Informal document **GRSG-107-18**
(107th GRSG, 30 September- 3 October 2014
agenda item 18)

Extended justifications to document GRSG/2014/24 - Regulation No. 118 (burning behaviour)

GRSG-106 requested OICA to provide clear information on the changes proposed per document ECE/TRANS/WP.29/GRSG/2014/24.

Figure 10 — Apparatus for resistance to flame propagation

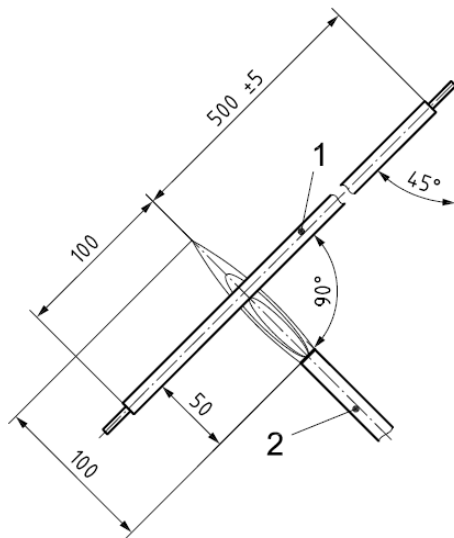
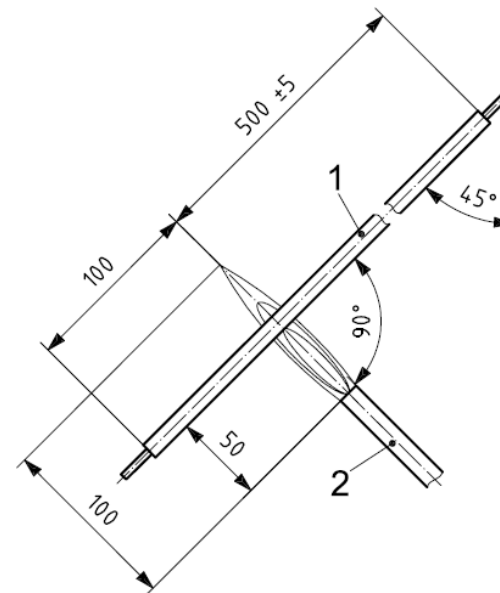
Determine the resistance to flame propagation using a Bunsen burner fed with appropriate gas, having a combustion tube of 9 mm internal diameter, where the flame temperature at the tip of the inner blue cone shall be $(950 \pm 50) ^\circ\text{C}$.

Determine the resistance to flame propagation using a Bunsen burner fed with appropriate gas, having a combustion tube of 9 mm internal diameter and a flame height of 100 mm. The length of the inner blue cone of the flame shall be 50 mm.

Suspend the test sample in a draught-free chamber and expose the test sample to the tip of the inner cone of the flame, as shown in Figure 10. The upper end of the cable shall point away from the closest wall of the chamber. The sample shall be subject to a stress, e.g. by means of a weight over a pulley, in order to keep it straight at all times. The angle of the cable shall be $45^\circ \pm 1^\circ$ relative to the vertical line. In any case, the shortest distance of any part of the sample shall be 100 mm minimum from any wall of the chamber. Apply the flame with the tip of the inner blue cone touching the insulation (500 ± 5) mm from the upper end of the insulation. Finish the exposure to the test flame when the conductor becomes visible, or after 15 s for cables with conductor sizes $\leq 2,5 \text{ mm}^2$ and 30 s for cables with conductor sizes $> 2,5 \text{ mm}^2$. Remove the flame sideways from the cable after exposure.

Suspend the test sample in a draught-free chamber and expose the test sample to the tip of the inner cone of the flame, as shown in Figure 10. Apply the flame (500 ± 5) mm from the upper end of the insulation. Finish the exposure to the flame when the conductor becomes visible, or after 15 s for test samples with conductor sizes $\leq 2,5 \text{ mm}^2$ and 30 s for test samples with conductor sizes $> 2,5 \text{ mm}^2$.

Any combustion flame of insulating material shall extinguish within 70 s from the end of ignition and a minimum of 50 mm of insulation at the top of the test samples shall remain unburned. All five samples shall pass the test.

Any combustion flame of insulating material shall extinguish within 70 s and a minimum of 50 mm of insulation at the top of the test sample shall remain unburned.
